APPLICATION FOR PERMISSION UNDER SECTION 16 OF THE TOWN PLANNING ORDINANCE (CAP. 131)

For Official Use Only 請勿填寫此欄	Application No. 申請編號	A / NE - MKT / 56
	Date Received 收到日期	14 NOV 2025

Planning Statement
S.16 Application for the
Proposed Temporary Warehouse for the Storage of Car Parts
And
Associated Filling of Land
for
A Period of 3 Years
At
Lot 664 S.A and Adjoining Government Land
In
DD 90
Man Kam To, New Territories

寄件者: TsangShun Qi <[REDACTED]>
寄件日期: 2025年11月19日星期三 11:27
收件者: Cheryl Tsz Man TSANG/PLAND
主旨: Submission of revised No. A/NE-MKT/56 document
類別: Internet Email

Layout plan

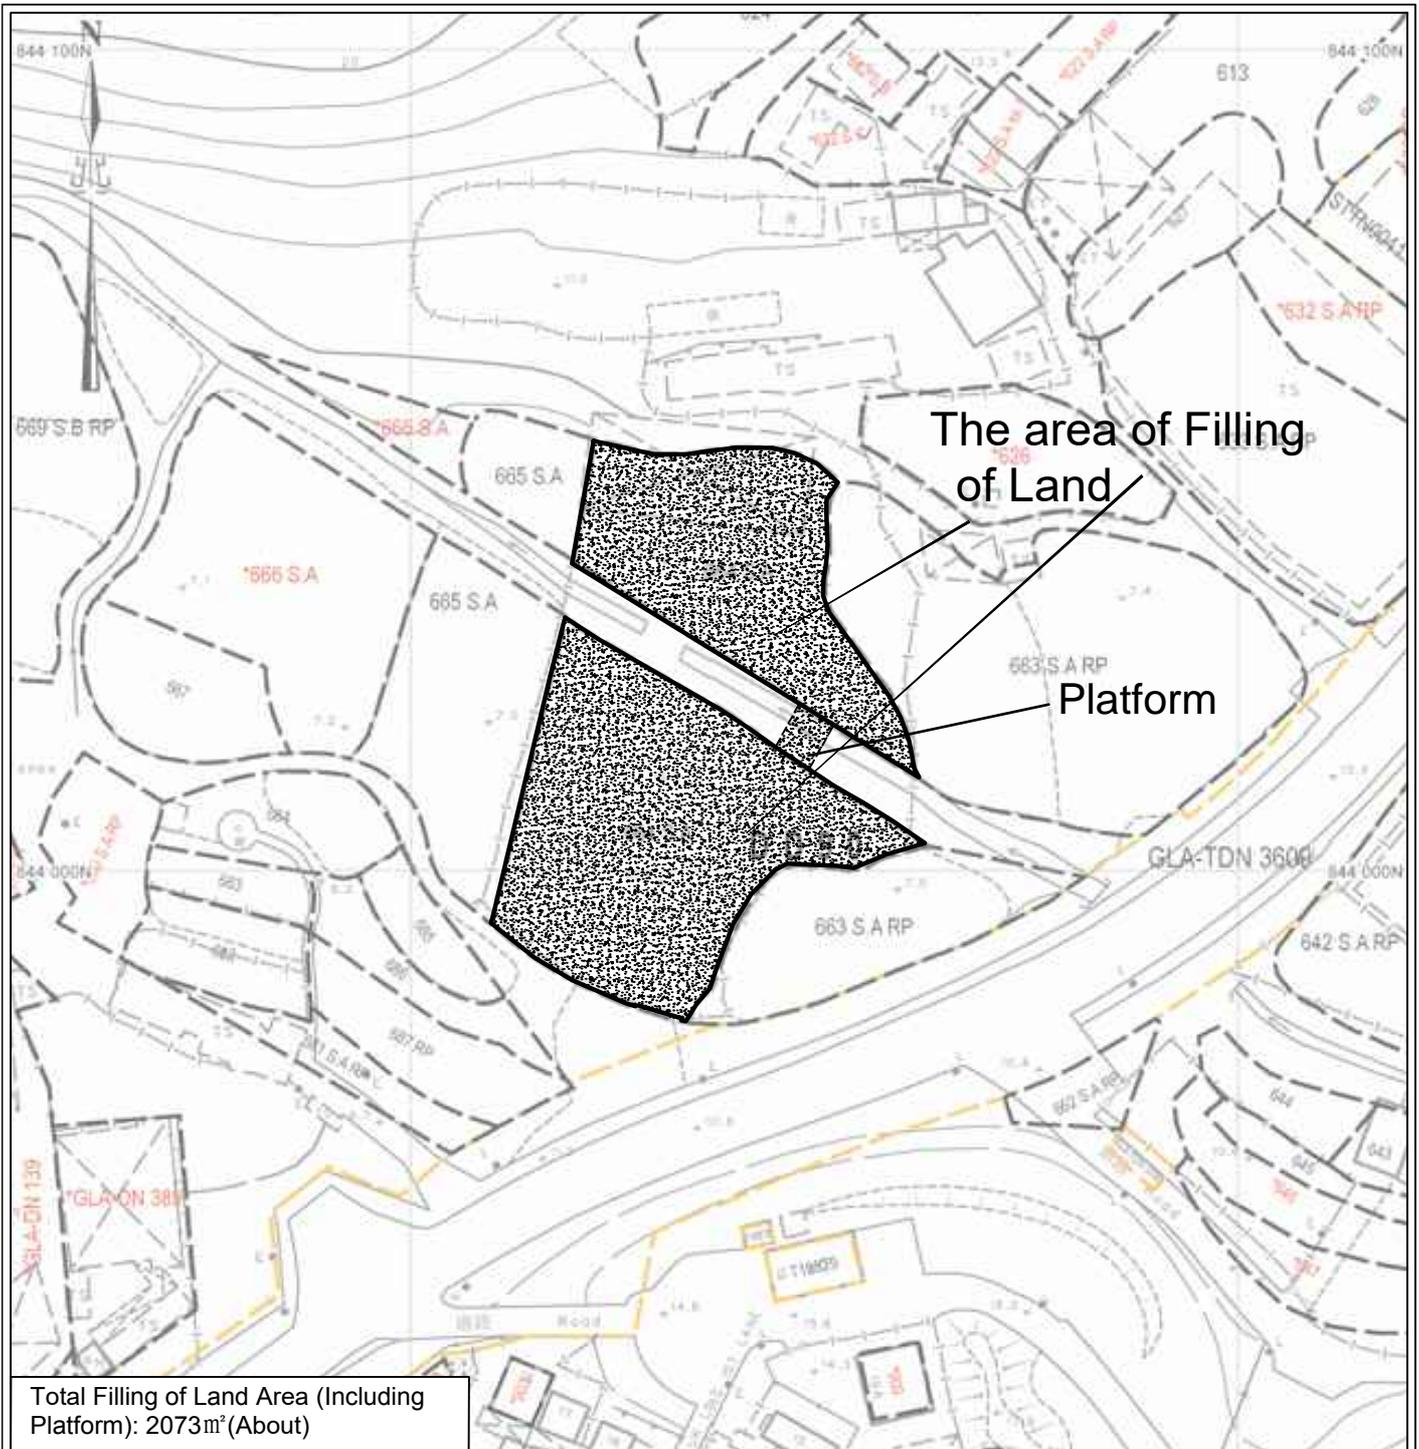
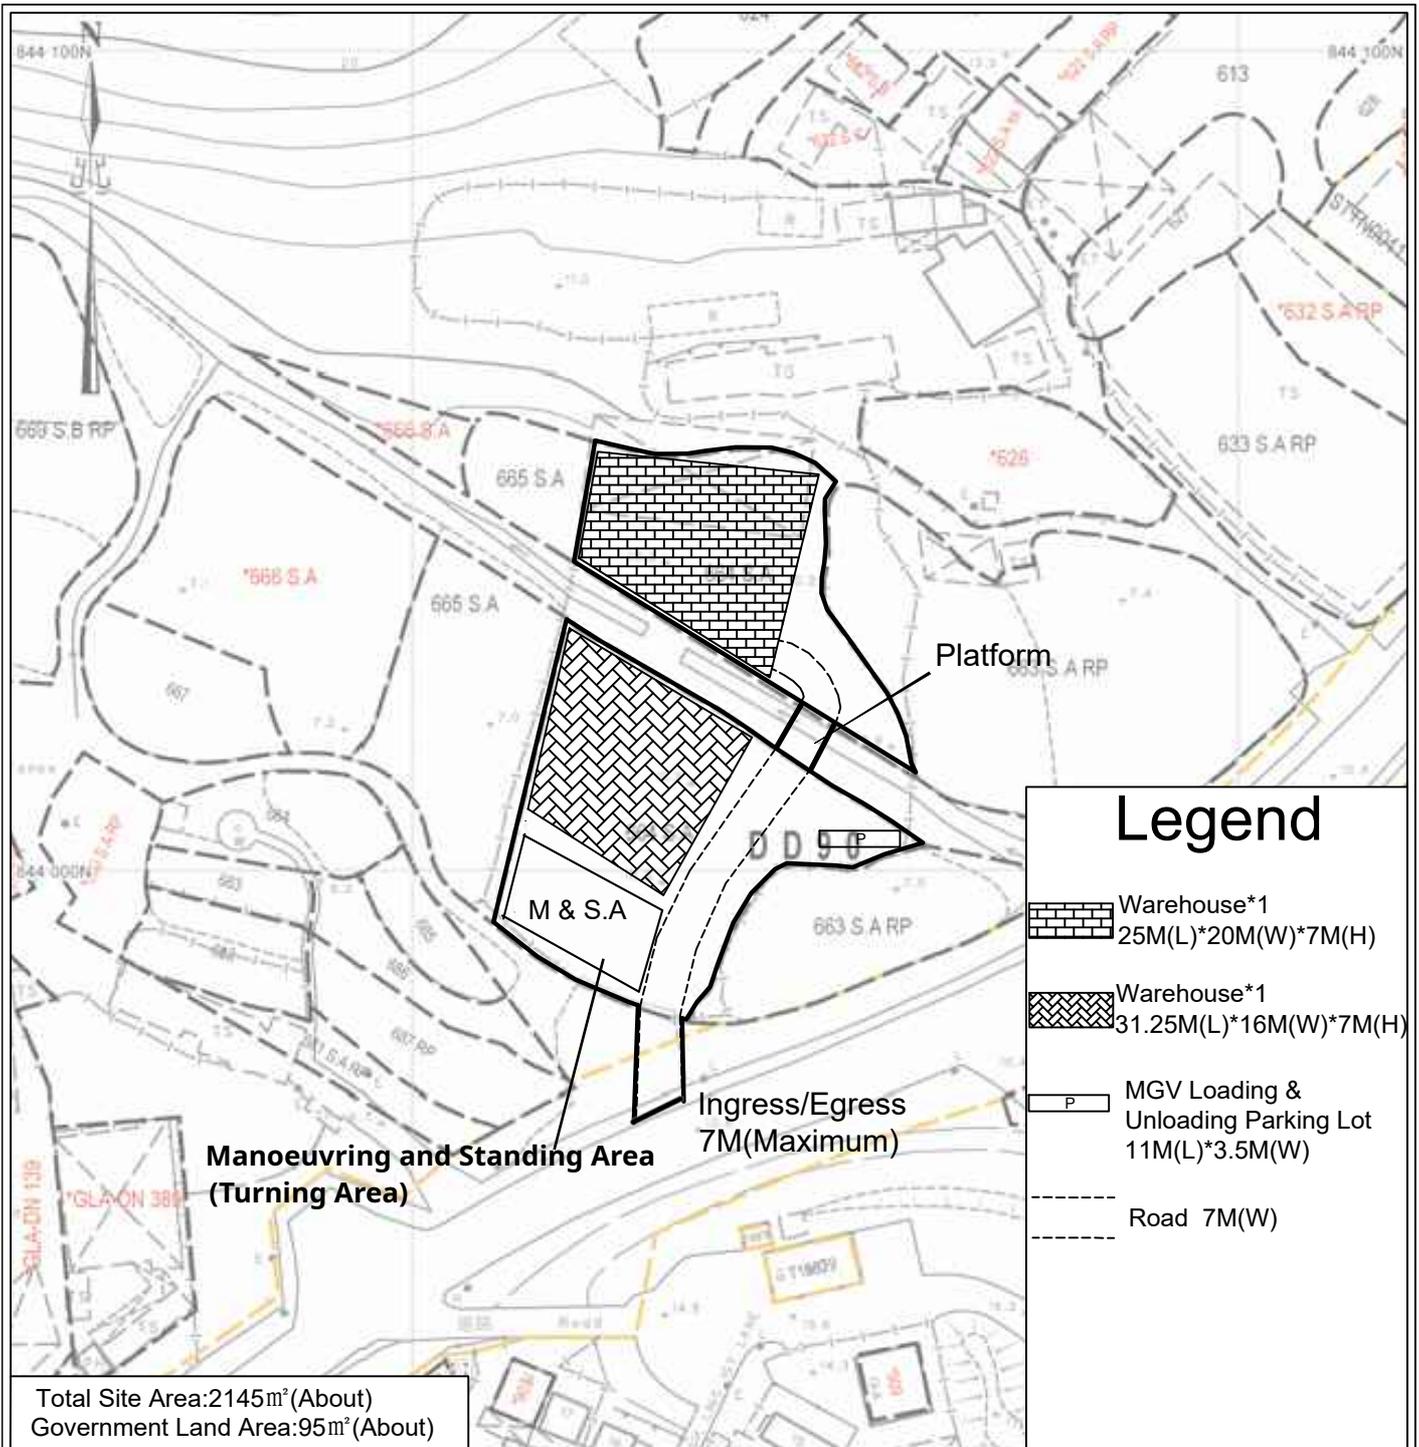
3. Layout Plan

- Revised the figure of the site area and Government land; and
- Clearly indicated the proposed vehicle turning area.

Title: Drainage Proposal - LAYOUT		D01
Drawn by: DM	Date: 6-10-2025	
Check by: DM	Scale: ---

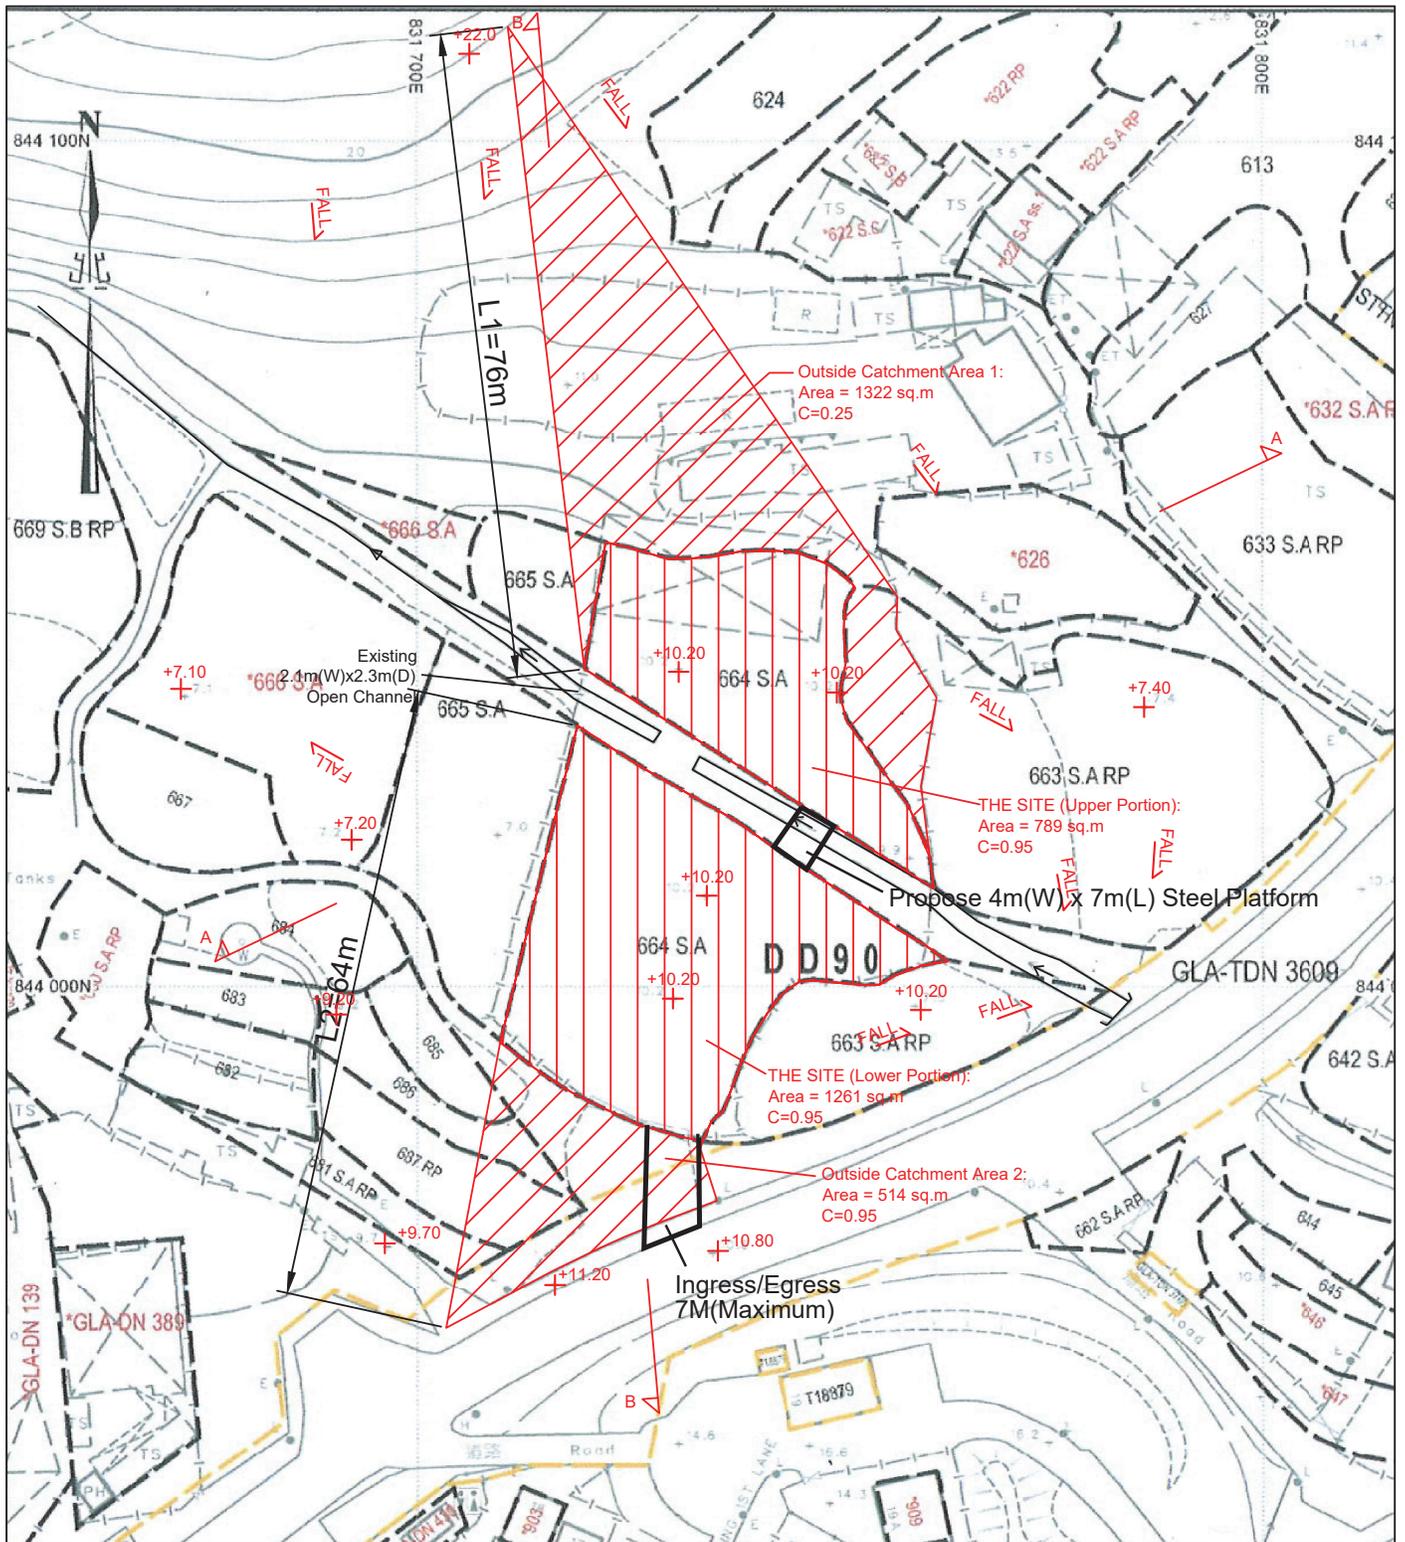
<p>would not be adversely affected by the proposed use and to avoid the Site from being eroded and flooded. The applicant is required to assess whether the downstream for drainage connection would have sufficient capacity to receive the stormwater runoff. Flood mitigation measures proposed in the DIA and any other stormwater drainage facilities should be provided and maintained by the applicant to the satisfaction of her office;</p>	
		<p>c. Drawing D01 refers. Please provide details including alignment, extent and invert levels of the proposed trapezoidal open channels. Also, please review if the invert level can effectively discharge the upstream surface runoff. If the drainage improvement works are to be conducted at the streamcourse within the fencing, please consider extend the area of the Site to include</p>	<p>The alignment, extent and invert levels of the proposed trapezoidal open channels have been presented in Drawing D01.</p>

- drawing D01 – the applicant should advise the fall ratio of the proposed trapezoidal open channel. The applicant should also study the invert level of immediate upstream and downstream streamcourse. Appropriate improvement works to level the flow path should be planned;

- drawing D01 – the applicant should review if flap valve is required for the proposed 375mm diameter pipe;
 - drawing D02 – the applicant should provide substantiation on the flow path to the south and east of the Site. As the elevated platform may block original flow path to the existing streamcourse within the Site, the applicant should ensure all the existing flow paths can be diverted to the proposed trapezoidal open channel;

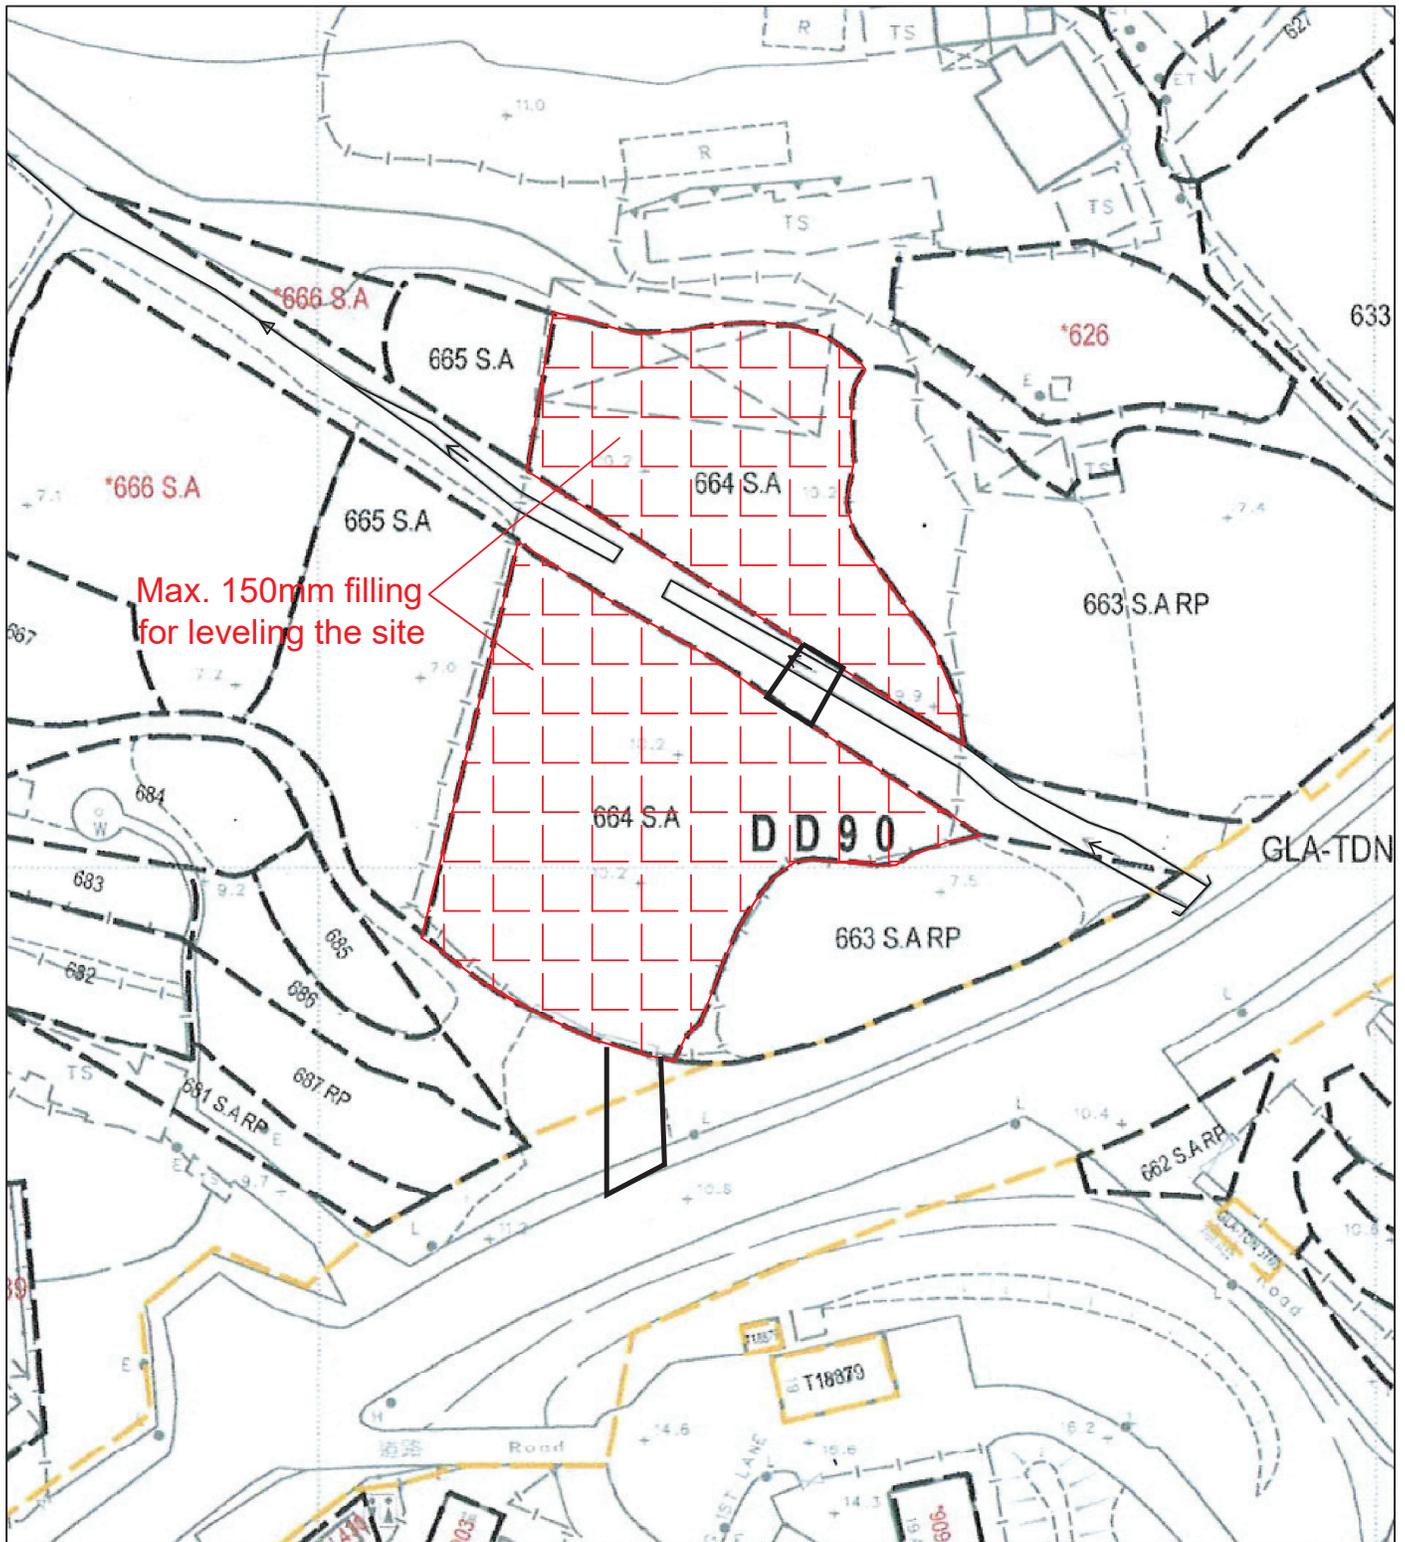
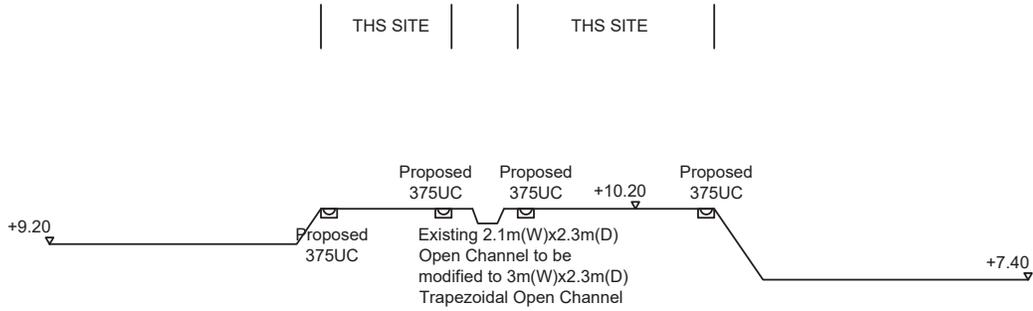
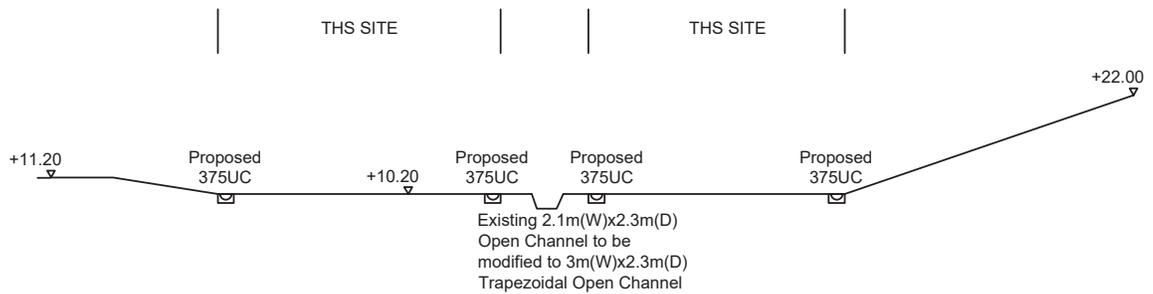
- drawing D03 – the applicant should indicate the original ground level and proposed ground level. If the ground level at external area as shown in Section A-A (i.e. +9.2mPD and +7.4mPD) is higher than original ground level while lower than the proposed ground level, original overland flow should be collected by the proposed drainage facilities. The applicant is reminded that all existing flow paths as well as the run-off falling onto and passing through the Site should be intercepted and disposed of via proper discharge points. The applicant shall also ensure that no works, including any site formation works, shall be carried out as may adversely interfere with the free flow condition of the existing drains, channels and watercourses on or in the vicinity of the Site any time during or after the works; and
